Real Property Data Search

P & Z File No. F-83-03

RE: F-82-83

OLD HACIENDA

Check box and return to Office of Planning and Zoning if plan is approved with no comments.

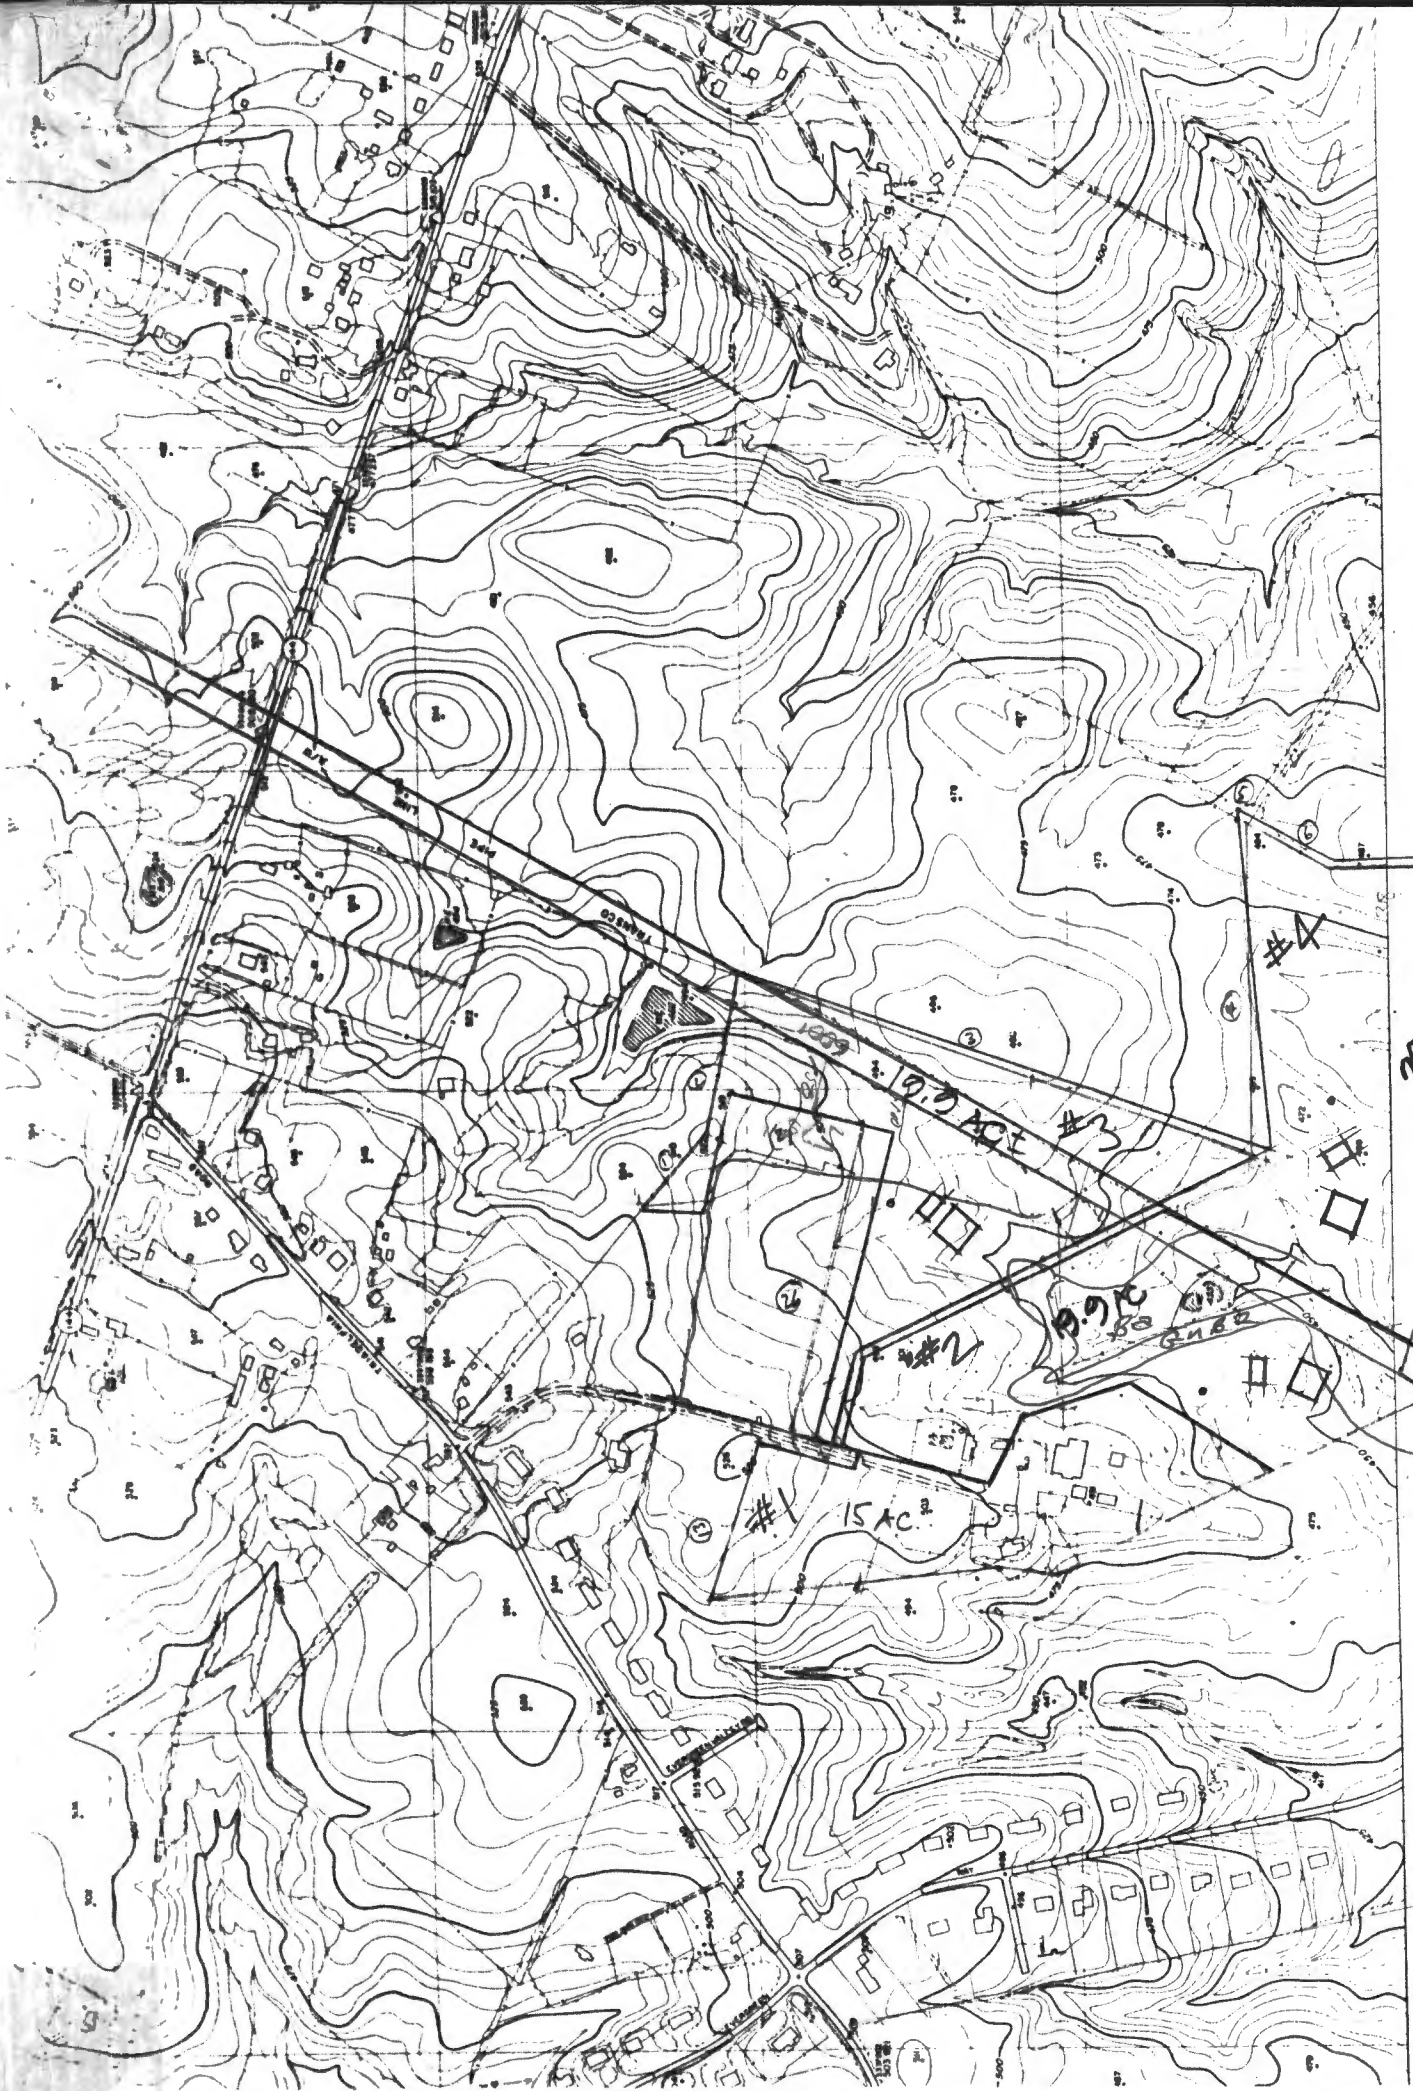
COMMENTS: Aug 3-10-82

SEE ATTACHED COMMENTS

1. THE LOTS SHOULD HEREBY COMPLY WITH THE MINIMUM OVERSEERSHIP WIDTH AND LOT AREA AS REQUIRED BY THE MARYLAND STATE DEPARTMENT OF HEALTH AND MENTAL HYGIENE.

2. THIS AREA DESIGNATES A PRIVATE SEWAGE EASEMENT OF 10,000 sq. ft. AS REQUIRED BY THE MARYLAND STATE DEPARTMENT OF HEALTH AND MENTAL HYGIENE FOR INDIVIDUAL SEWAGE DISPOSAL IMPROVEMENTS OF ANY NATURE IN THIS AREA ARE RESTRICTED UNTIL PUBLIC SERVICE IS AVAILABLE. THESE EASEMENTS SHALL BECOME NULL & VOID UPON CONNECTION TO A PUBLIC SEWAGE SYSTEM. THE COUNTY HEALTH OFFICER SHALL HAVE THE AUTHORITY TO SUEUT VANDAUCEY FOR DELINQUENCY IN THIS MATTER. THE PRIVATE SEWAGE ESMT. RECORDATION OF A 10,001 SQ. FT. SEWAGE ESMT. SHALL NOT BE NECESSARY.
3. EXISTING STRUCTURE ON LOT 1

FIELD SHEET

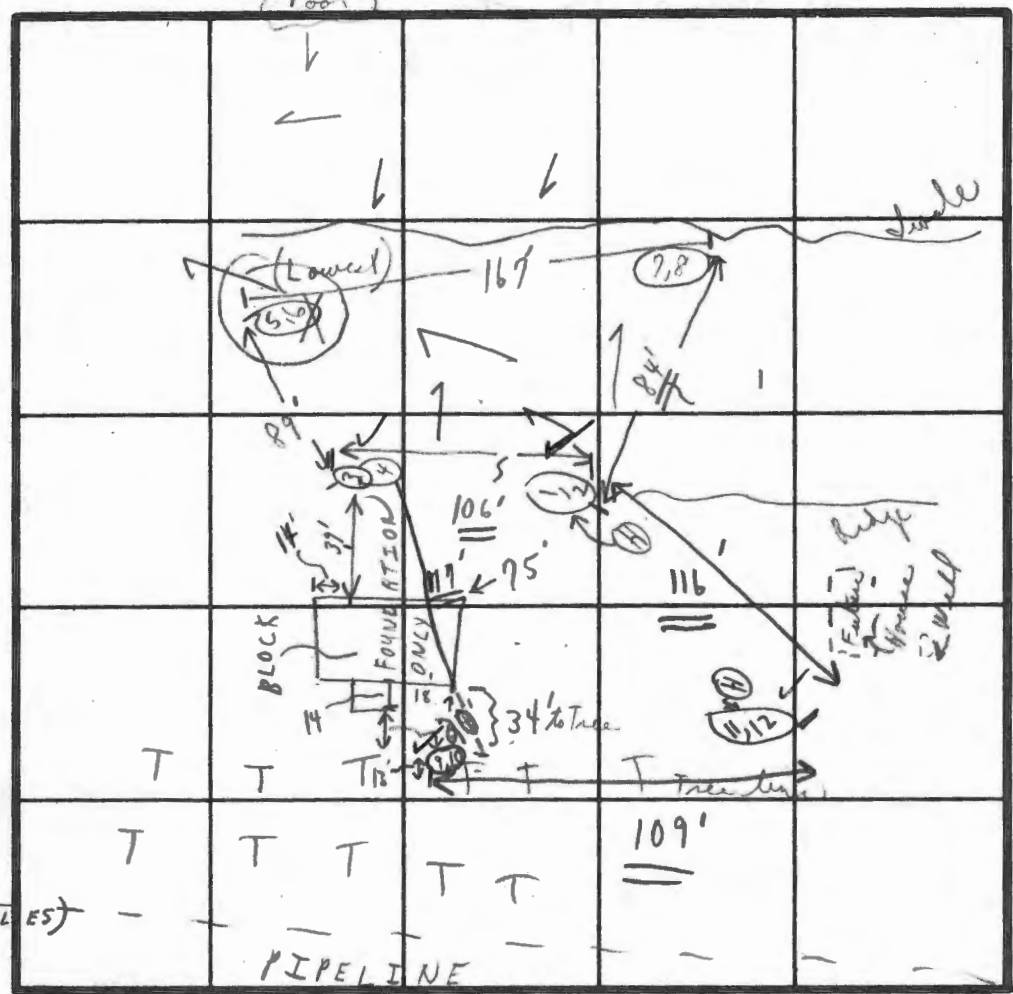
REASONS FOR REJECTION OR HOLDING 2/23/81 FOR CERTIFIED HOLES; WATER WELL SET
HOUSE SITE; AND REPAIR OF EXISTING SYSTEM ON LOT 1
C.B.d.

(HOLES DUG @ TIME OF ARRIVAL)
(WATER - HOLD FOR WET SEASON; +/OR REDESIGN)
TESTS IN OPEN FIELD

System repaired on Lot 1 (P32264).

FIELD SHEET

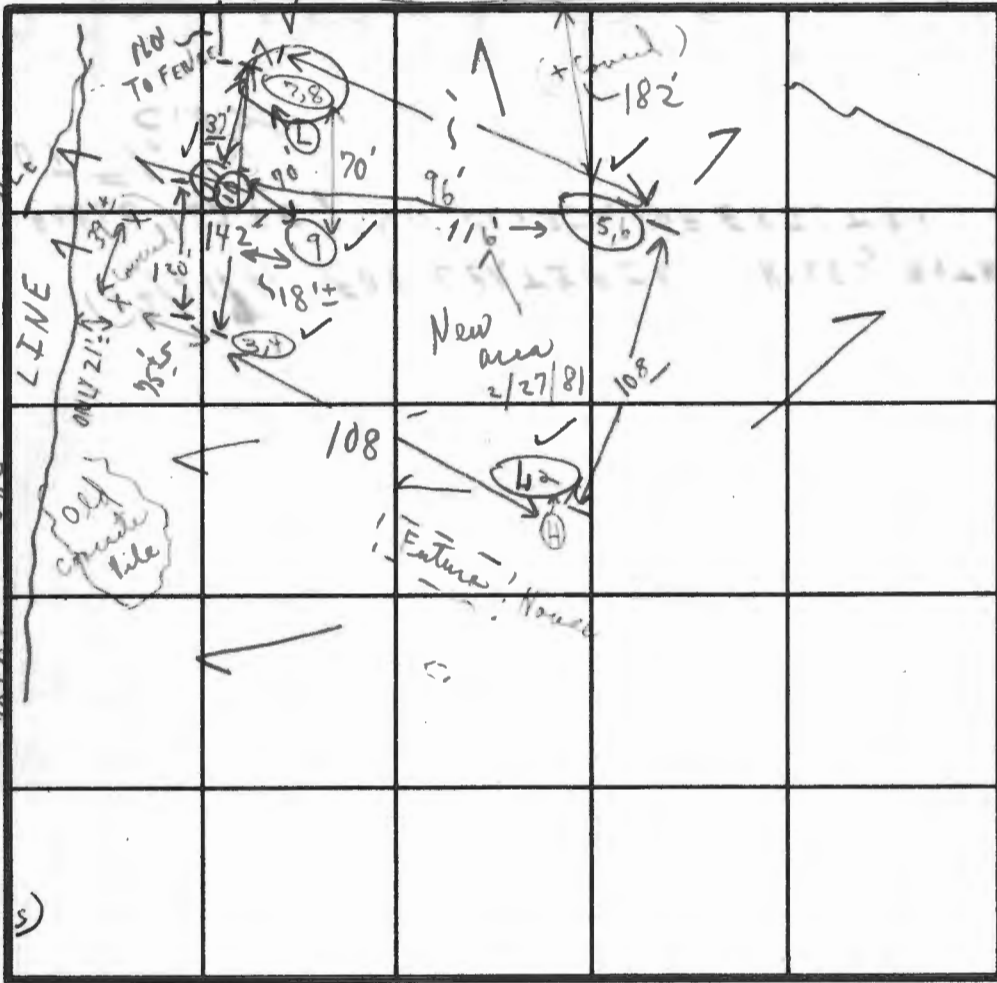
REASONS FOR REJECTION OR HOLDING 2/28/81 FOR CERTIFIED HOLES; WATER WELL SITE; HOUSE SITE, AND REPAIR OF EXISTING SYSTEM ON LOT #1. C.B.D.

System repaired on Lot 1 (P 32264)

FIELD SHEET

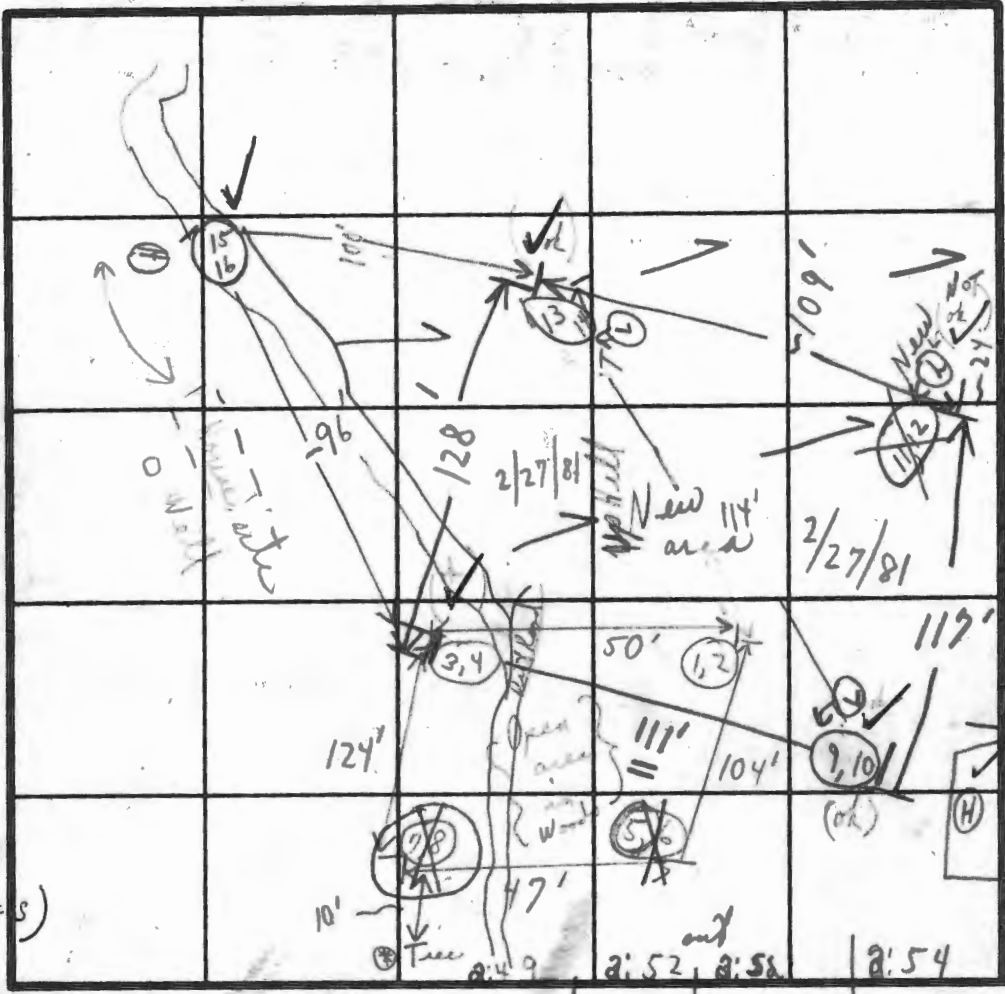
REASONS FOR REJECTION OR HOLDING 2/27/81 HOLD FOR CERTIFIED HOLES, HOUSE

SITE; SHALLOW TRENCHES ONLY 3'-5' DEEP; WATER WELL SITE,
ALSO FOR REPAIR ON #1 LOT'S SEPTIC SYSTEM. C.B.V.

Dug to 13' No water @ 25' HOLES PUC + REEDYS
 REMARKS: Trench to 12' } LOT IN WOODS } HOLD FOR CERTIFIED
 (Tree has initials @ B carved in) }
 TESTED BY: C.B.D. (9,10) Hole 2' higher than (11,12) } L. QUESENBERY
 ALSO PRESENT: Mr. Wunder }

System repaired on Lot 1 - (P32264)
SEWAGE DISPOSAL TESTING

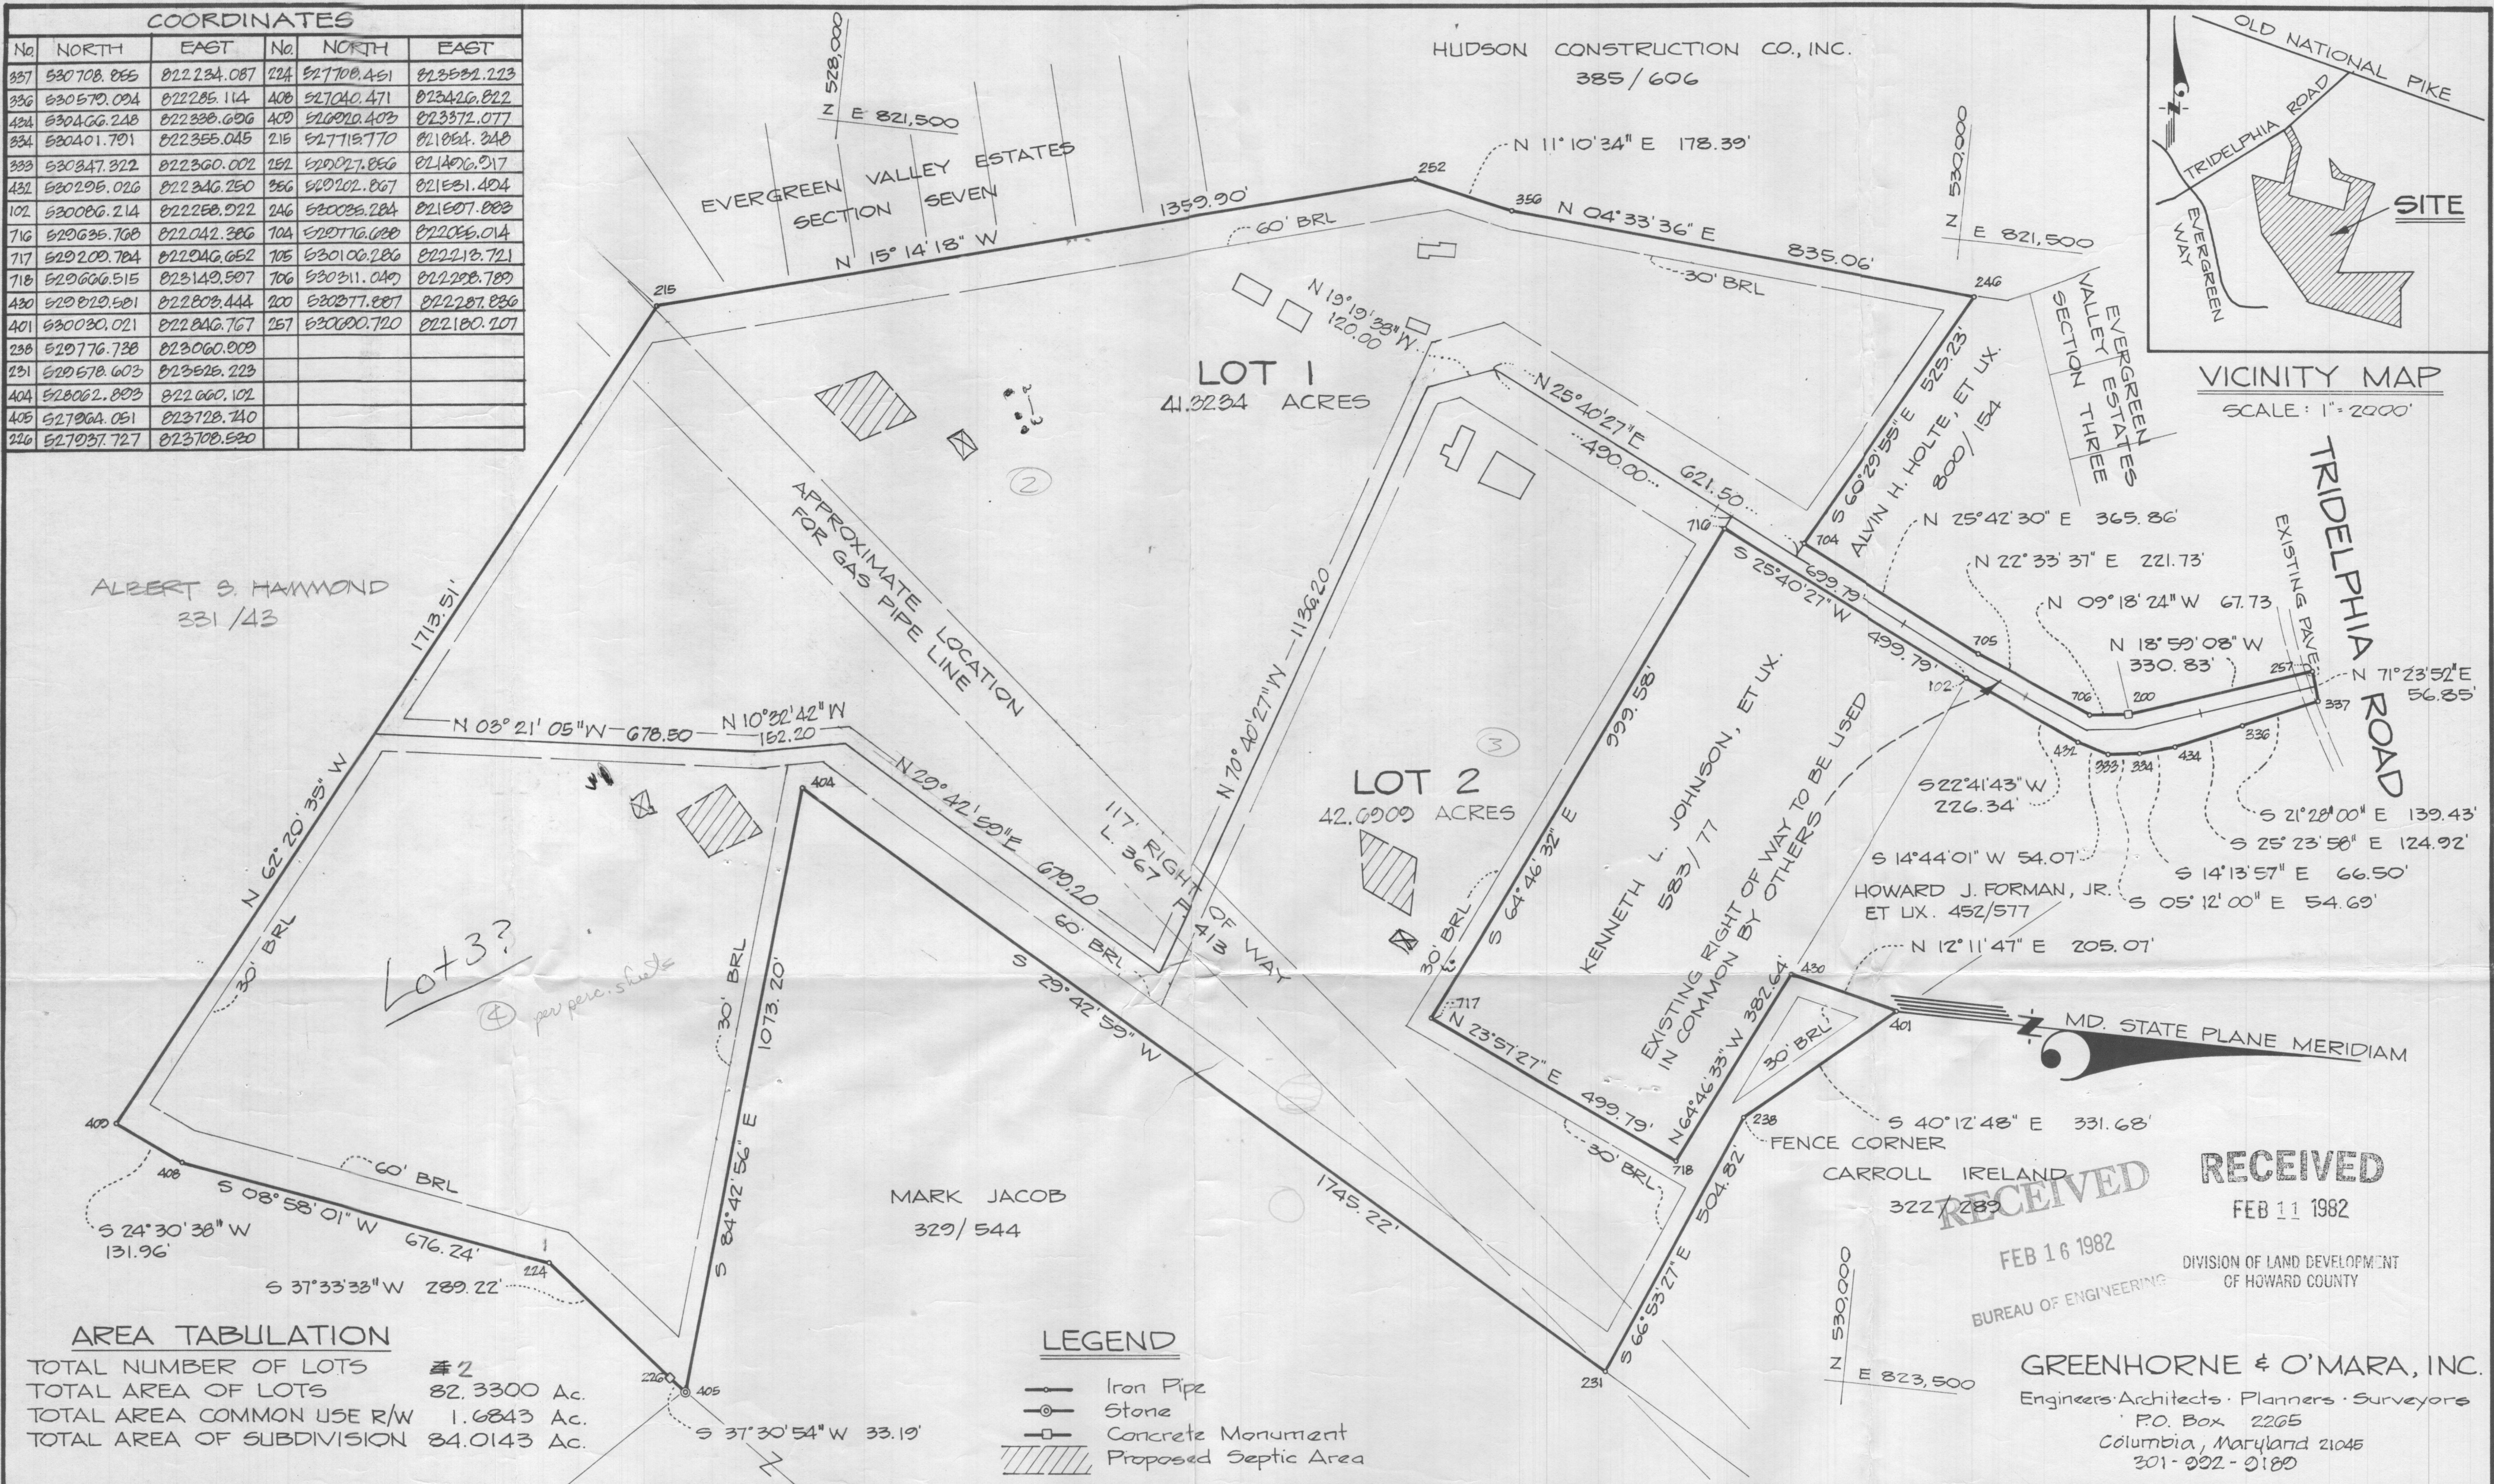
| <input checked="" type="checkbox"/> Final plat needs revising. | <input type="checkbox"/> State Subdivision Regulations not complied with. |

OTHER COMMENTS: The attached notes must be added to final record plat. Each lot must have a lot number on plat
